Access Compliance Report

Public Rights-of-Way

(Curb Ramps)

Intersection ID: 23437	Main Street: TRYON_ST	Cross Street: MOSS_RD	Location: NW
ADA ID: 968087E1F215	Ramp Type: MedianPerp	Initial Pass/Fail: Fail	Overall Compliance: No
			Severity Score: 21.25

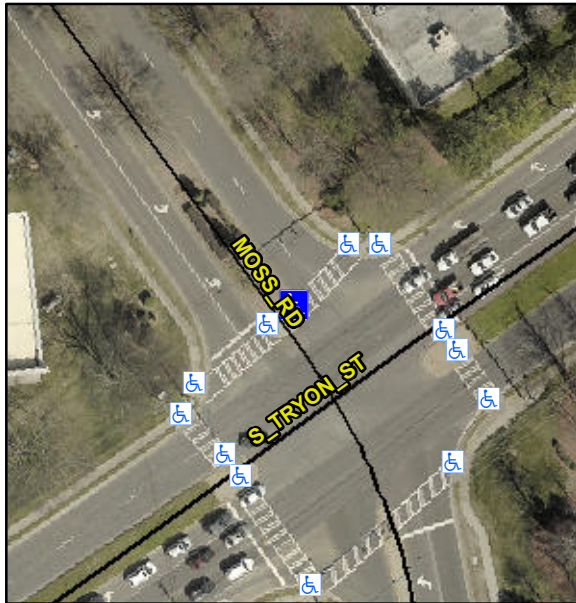
Not Found, R304.5.1, R304.2.2

Compliance	Description	Data	Compliance	Description	Data
N/A	Ramp Length (in)	46.0	No	Ramp Slope (%)	9.8
No	Ramp Width (in)	41.0	Yes	Ramp XSlope (%)	0.0
N/A	Flare Type LT	N/A	N/A	Flare Type RT	N/A
N/A	Flare Slope LT (%)	N/A	N/A	Flare Slope RT (%)	N/A
N/A	Flare Traversable LT?	N/A	N/A	Flare Traversable RT?	N/A
N/A	Landing Length (in)	N/A	N/A	DWS Provided?	N/A
N/A	Landing Width (in)	N/A	N/A	DWS Contrast?	N/A
N/A	Landing Slope (%)	N/A	N/A	DWS Length (in)	N/A
N/A	Landing X Slope (%)	N/A	N/A	DWS Full Width?	N/A
N/A	Landing Curb? (Y/N)	N/A	N/A	DWS Offset (in)	N/A
N/A	Shared Landing?	N/A			
N/A	Gutter Ponding?	N/A	N/A	Gutter Slope (%)	N/A
N/A	Gutter Lip Ht (in)	N/A	N/A	Gutter X Slope (%)	N/A
N/A	Painted X Walk1?	Yes	N/A	Painted X Walk2?	N/A
	X Walk 1 Direction	To E		X Walk 2 Direction	N/A
N/A	X Walk 1 Width (in)	115.0	N/A	X Walk 2 Width (in)	N/A
	X Walk 1 Slope (%)	3.2		X Walk 2 Slope (%)	N/A
	X Walk 1 X Slope (%)	3.4		X Walk 2 X Slope (%)	N/A

Remove & Replace Entire Ramp.
